Access Compliance Report Public Rights-of-Way (Curb Ramps)

Main Street: CONTIGO_PL Cross Street: RIBERA_RD Location: NE

ADA ID: RPRK211117163723 Ramp Type: Type 4 - Parallel Initial Pass/Fail: Pass Overall Compliance: No Severity Score: 5

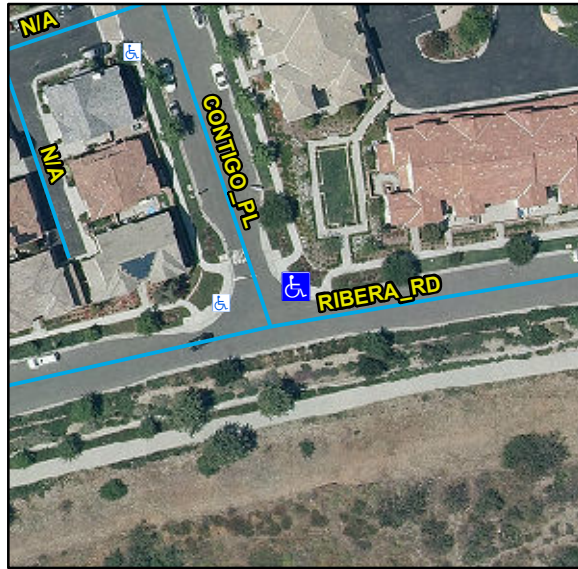
Crossing 1 Slope (%)	0		Crossing 2 Slope (%)	2.3
	Crossing 1 Cross Slope (%)	1.2		Crossing 2 Cross Slope (%)	0.4
Yes	Gutter Ponding	No	Yes	Curb Slope	4.3
Yes	Gutter Lip Height (in)	0		Road Run Slope (%)	1.2
No	Gutter Run Slope (%)	8		Road Cross Slope (%)	1.6
Yes	Gutter Cross Slope (%)	0.5	Yes	Perpendicular Joint Present	Yes
Yes	Overall Surface Condition	Acceptable			
	Cross Gutter Present?	No		Spandrel Present?	No
	Replace Cross Gutter?	N/A		Replace Spandrel?	N/A

Remove & Replace Gutter.

R304.5.4, STD 1115
